Research, Designs & Standards Organization, LUCKNOW - 225011

Modification Sheet No. RDSO/2008/EL/MS/ 0367/Rev '0' Dated-29.98.08

Modification of Mounting Arrangement of MCB-100 (Circuit Breaker Battery Charger) fitted in Auxiliary Converter (BUR3 / BOX2) of 3-phase electric locos.

1. MCB-100 located inside BUR-III

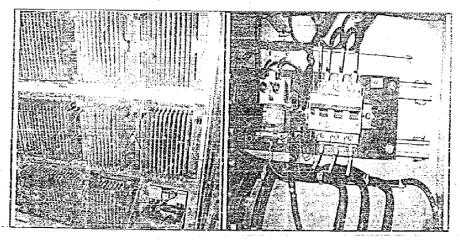
At present, MCB-100 is fitted inside BUR-3 of auxiliary converter as per ABB's drawing No. 3EHE310190

MCB-100 to be shifted from inside BUR-3 to HB-2 panel as shown in circuit drawing no.SKEL-4750,ALT '0' and photographs attached.
